**TOWN OF SHADY SHORES  
PLANNING AND ZONING COMMISSION  
MARCH 16, 2016, 7:00 PM  
SHADY SHORES COMMUNITY CENTER  
101 S. SHADY SHORES ROAD  
SHADY SHORES ROAD, TX 76208**

**To:** Allen Lea, Chairman and Commissioners  
**From:** Wendy Withers, Town Secretary  
**CC:** Jim Shepherd, Town Attorney  
**Date:** 03/10/2016  
**Re:** Steinbrunner Replat

**MINOR REPLAT**  
**HIDDEN VALLEY AIRPARK, PHASE V**  
**LOT 155S-R**  
 being a replat of Lots 155S and 156S of  
 Hidden Valley Airpark, Phase V, recorded in  
 Cabinet Y, Page 673, Plat Records, Denton County, Texas  
 2.251 acres out of the  
 W. Durham Survey, Abst. No. 330  
 Town of Shady Shores, Denton County, Texas

CONCEPT PLAN  
HIDDEN VALLEY  
LOT 155S-R

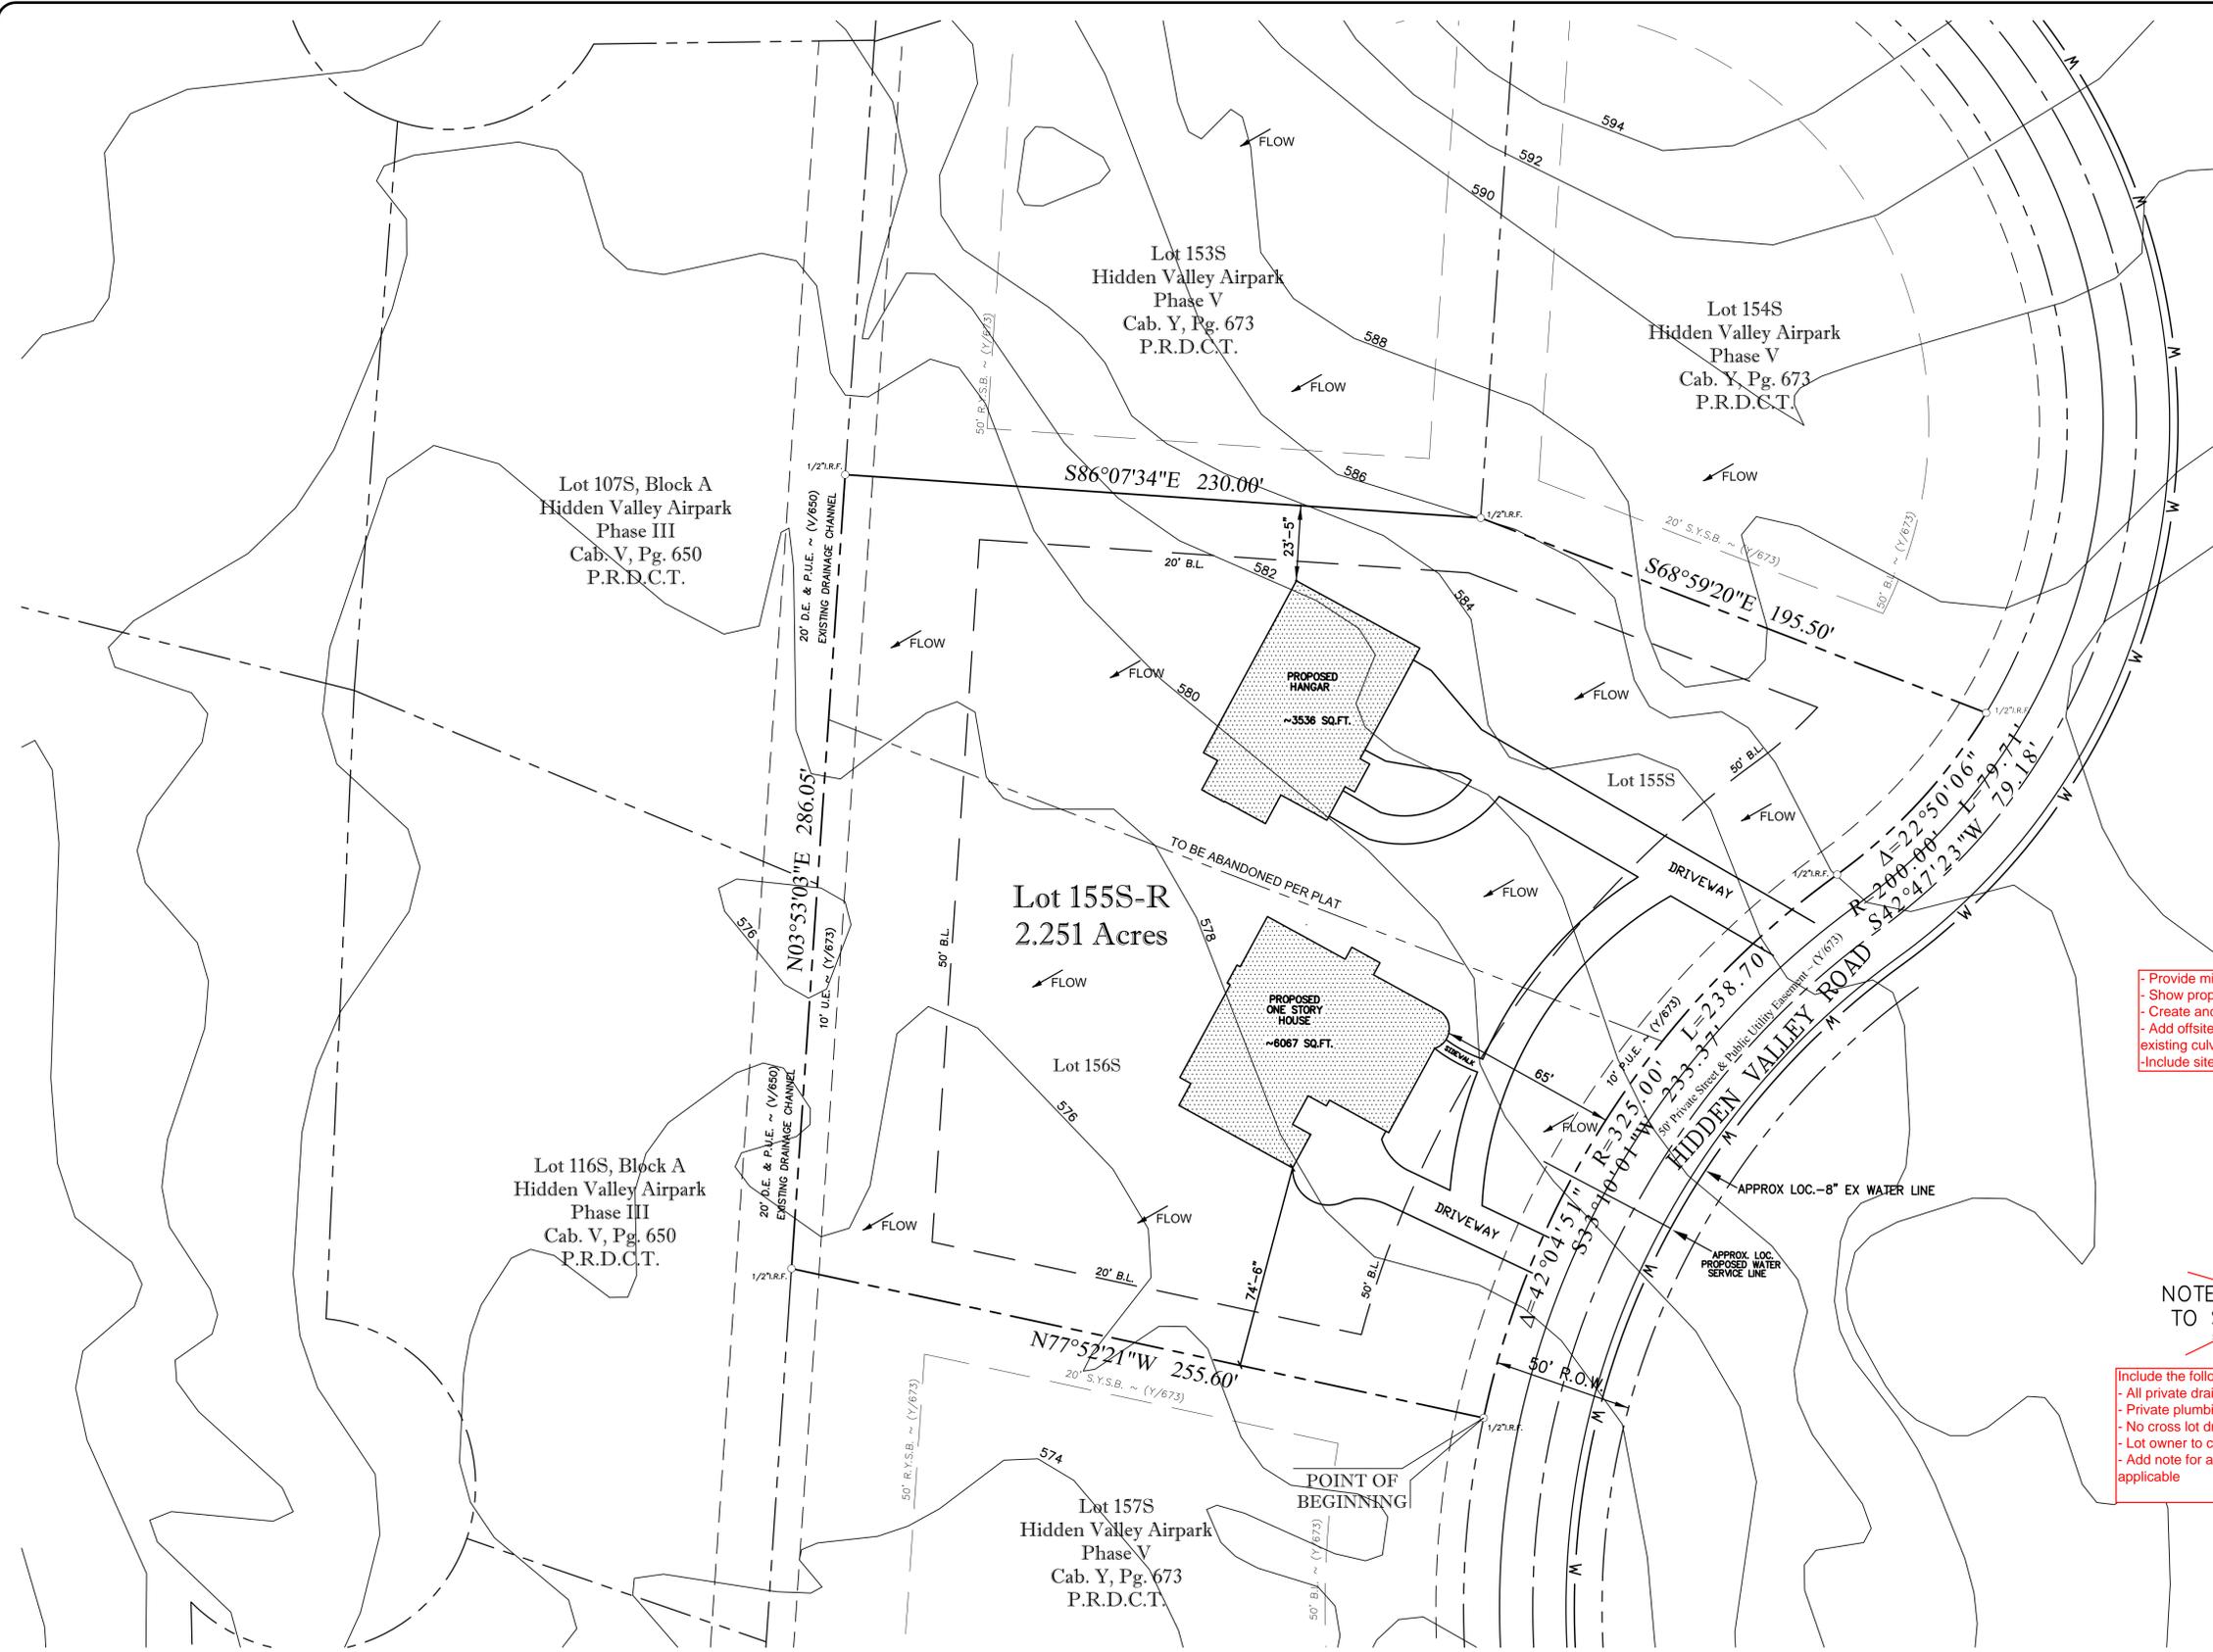
Include the following notes:  
 - All private drainage easements are to be maintained by property owners  
 - Private plumbing will not be allowed across property lines  
 - No cross lot drainage will be allowed between Lots 155S-R and 157S  
 - Lot owner to connect to sewage collection system when made available  
 - Add note for and show site bench mark and reference to NAVD88 or as applicable

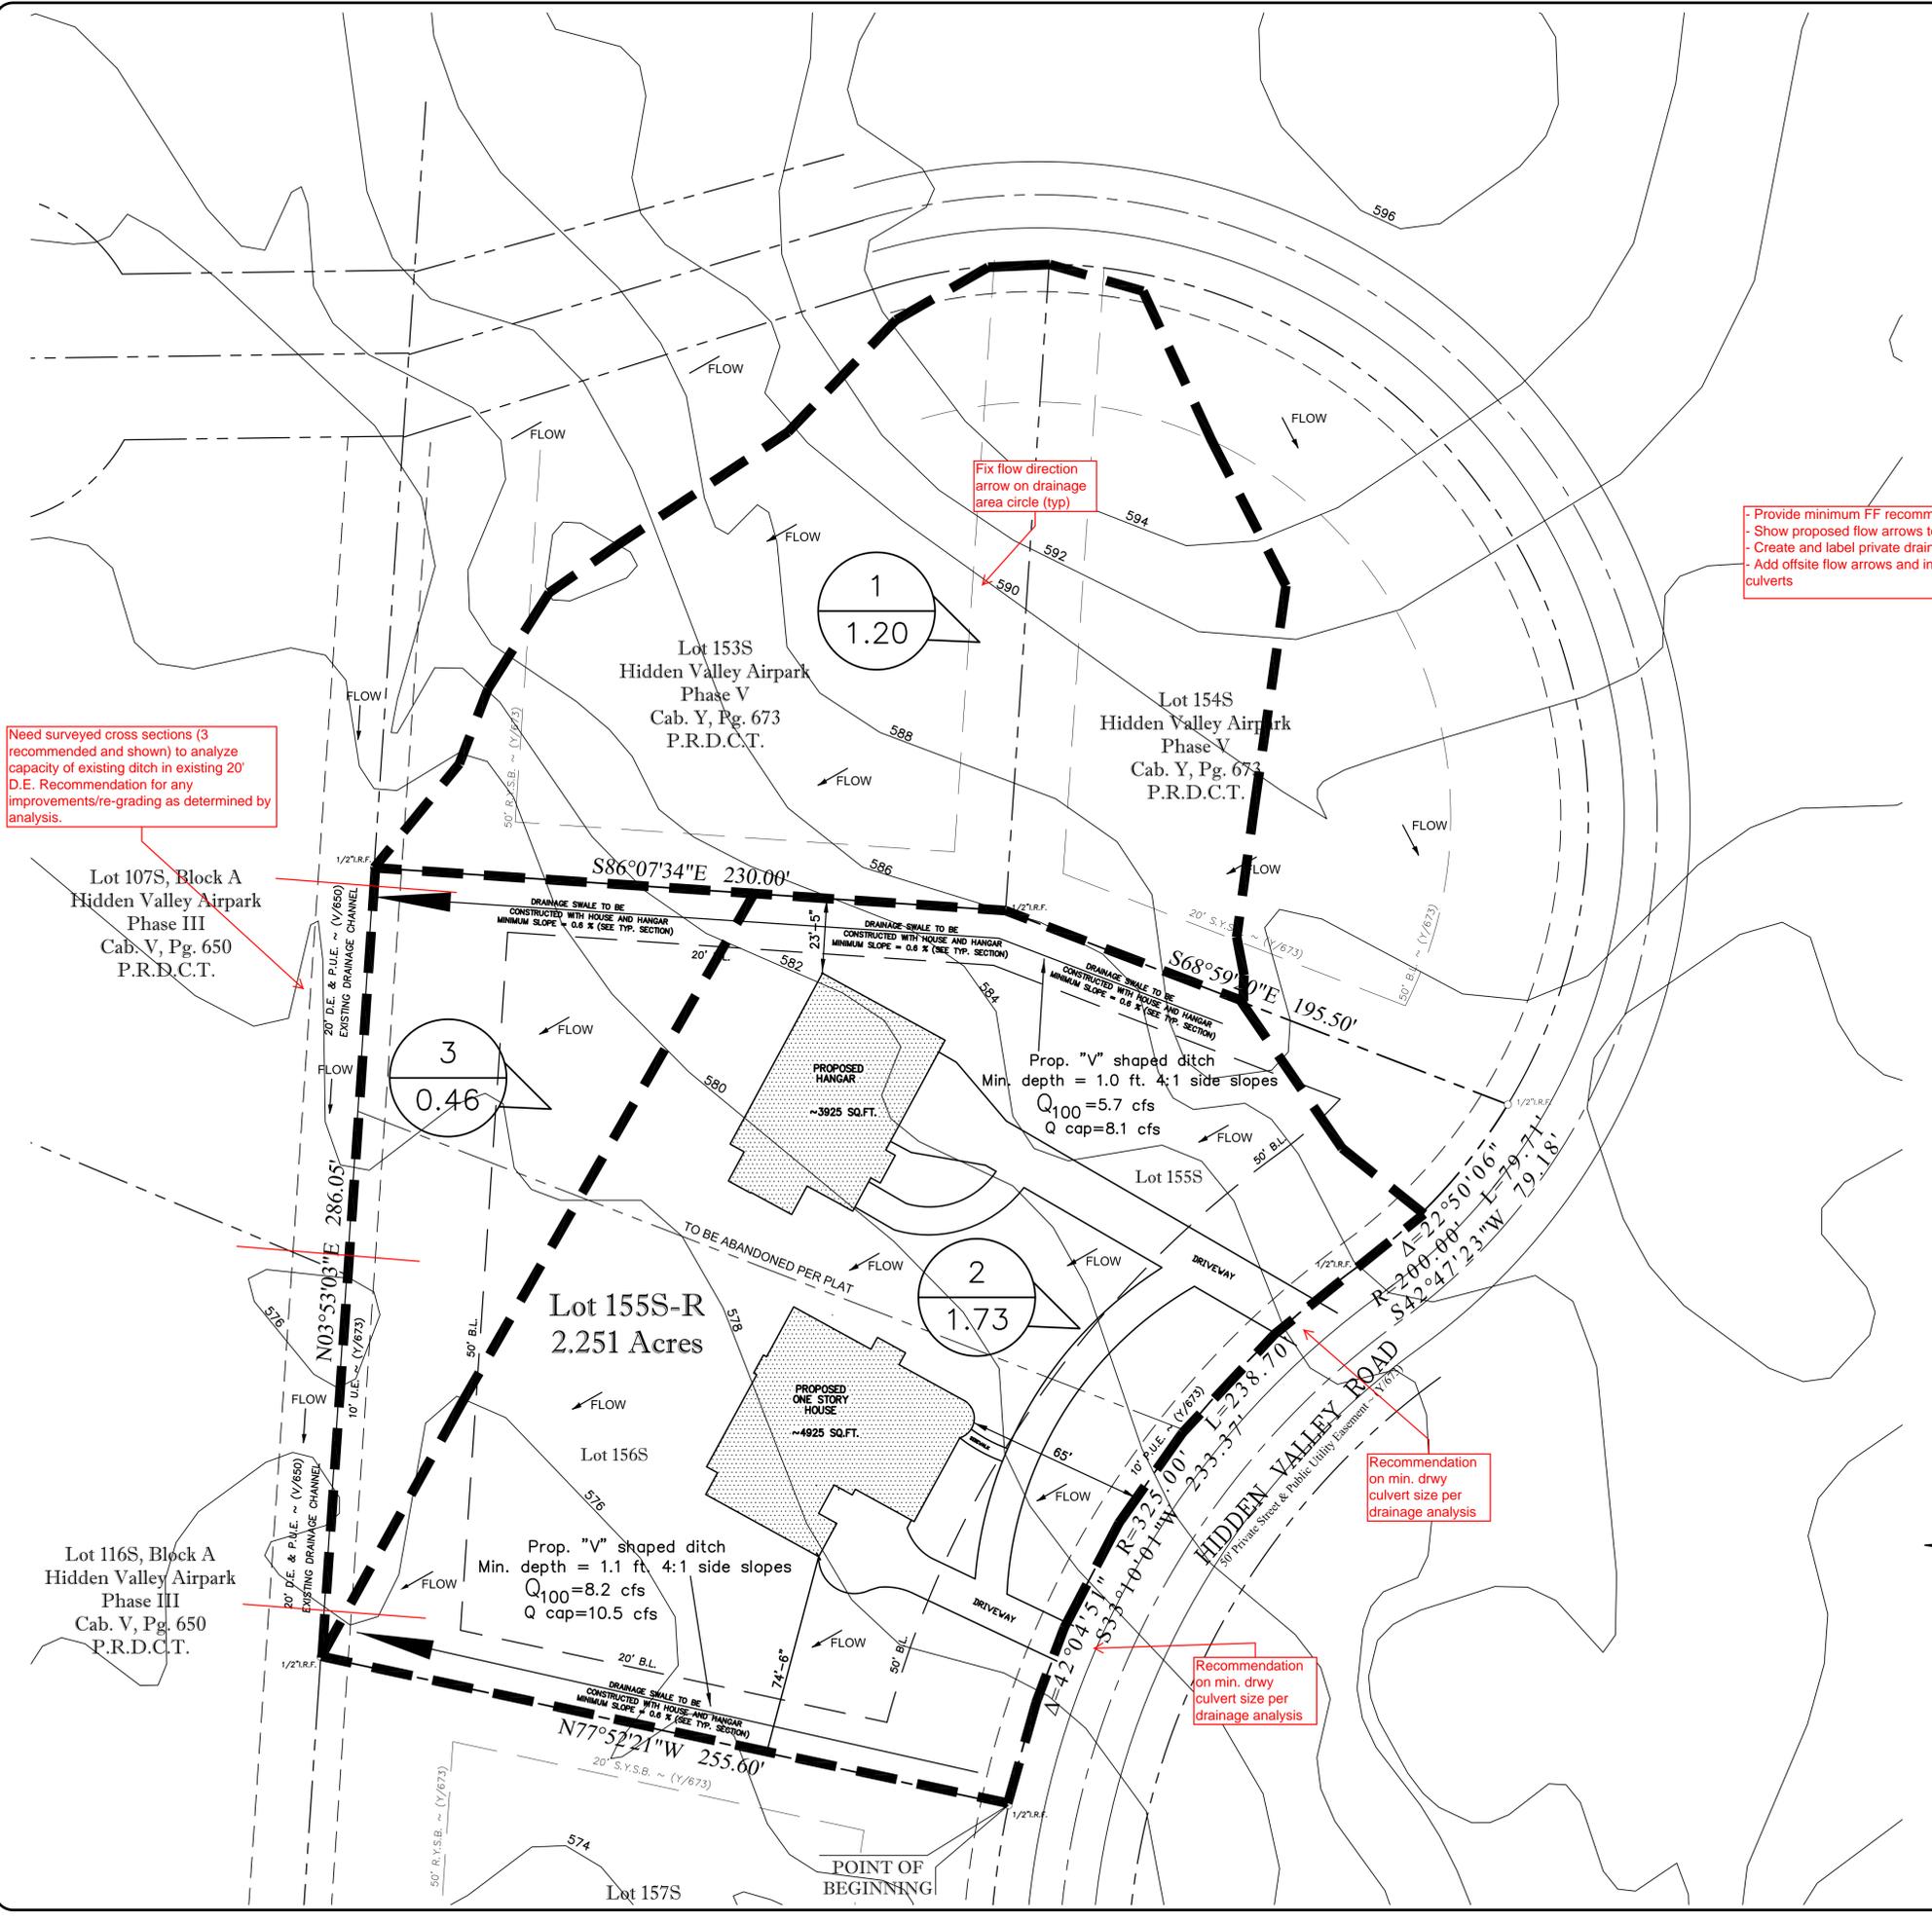
- Provide minimum FF recommendation for both buildings
- Show proposed flow arrows to demonstrate proposed grading
- Create and label private drainage easements (15' min. width)
- Add offsite flow arrows and indicate roadside ditches and existing culverts
- Include site benchmark (NAVD88)

- Include the following notes:
- All private drainage easements are to be maintained by property owners
- Private plumbing will not be allowed across property lines
- No cross lot drainage will be allowed between Lots 155S-R and 157S
- Lot owner to connect to sewage collection system when made available
- Add note for and show site bench mark and reference to NAVD88 or as applicable

PROPOSED DRAINAGE DITCH PLAN  
 HIDDEN VALLEY AIRPARK  
 LOT 155S-R

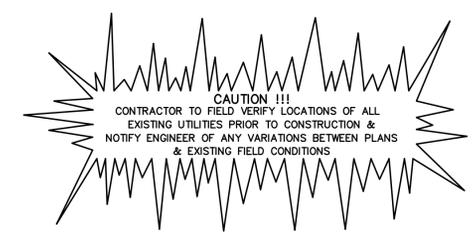
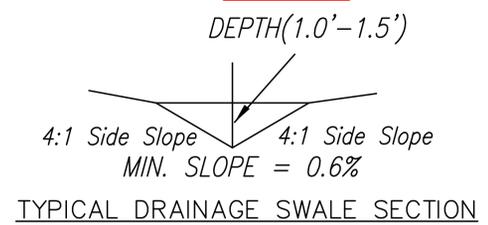
0.45 per Table 1.6 (+ acres lots)

7.91 per Table 5.3 (Denton County)
